# City of Portland Design Commission

## Design Advice Request

**Mailed:** August 26, 2019  
**Date:** August 22, 2019  
**To:** Mark Atteridge, Mortenson Construction  
**From:** Tim Heron, Design Review  
53-823-7726, tim.heron@portlandoregon.gov  
**Re:** EA 19-176793 DA – Everett Hotel, 234 NW 14<sup>th</sup> Avenue  
Design Advice Request Commission Summary Memo – August 8, 2019

## EVERETT HOTEL

GROUND LEVEL FLOOR PLAN

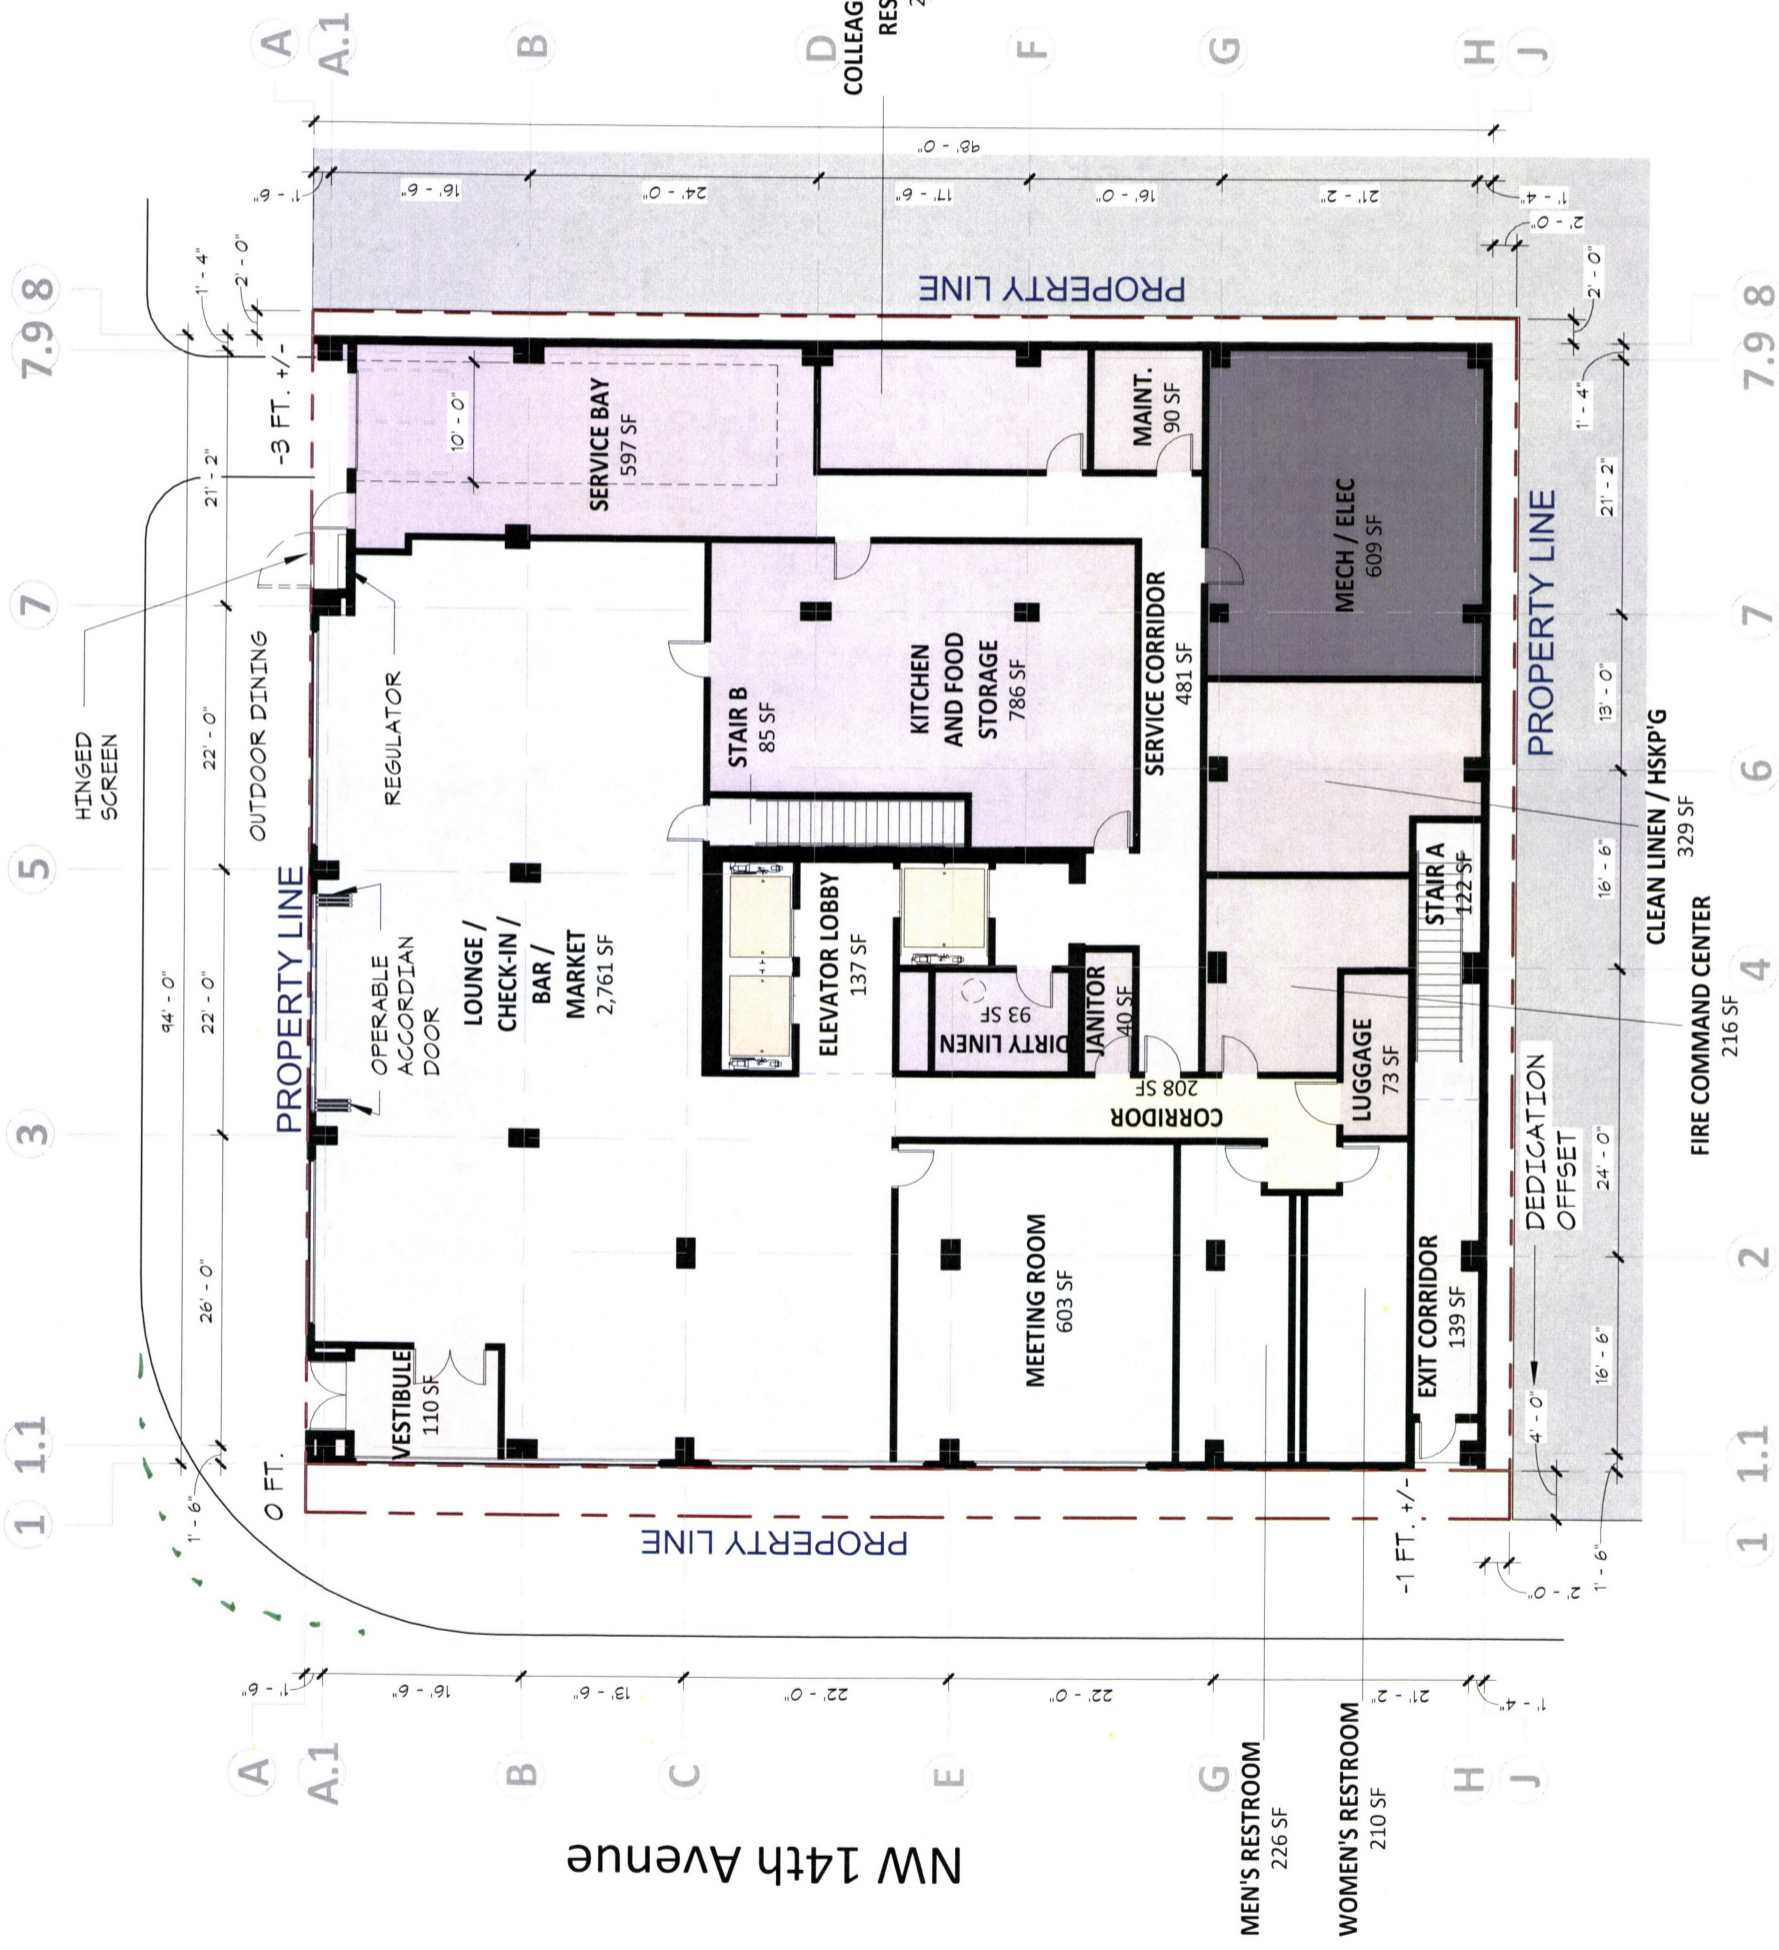
- The majority of the Commission supported the 15' floor to floor measurement provided the clearance at the first floor level was a minimum of 14'.
- Critical concerns were raised regarding the sidewalk radius at NW 14<sup>th</sup> Avenue and NW Everett Street having a possible 6' maximum clearance from the building corner.

- The main entrance for the hotel should be pulled away from the corner, perhaps located mid-block.
  - Continue to explore other design options along NW Everett Street given the high volume intersection – both cars and people – at the NW 14<sup>th</sup> Avenue and NW Everett Street corner.

- Bathroom frontage along NW 14<sup>th</sup> Avenue is a non-starter. Bathrooms must be internal to the building, and Active Uses along the street frontages.

- Bike parking will need to be provided and should be programmed onto the ground floor as soon as possible given the limited area of the 1/4 -block footprint.

- Develop more places to stop and rest along NW Everett Street.
  - Additional recesses at the ground floor plane should be considered, particularly along NW Everett Street.
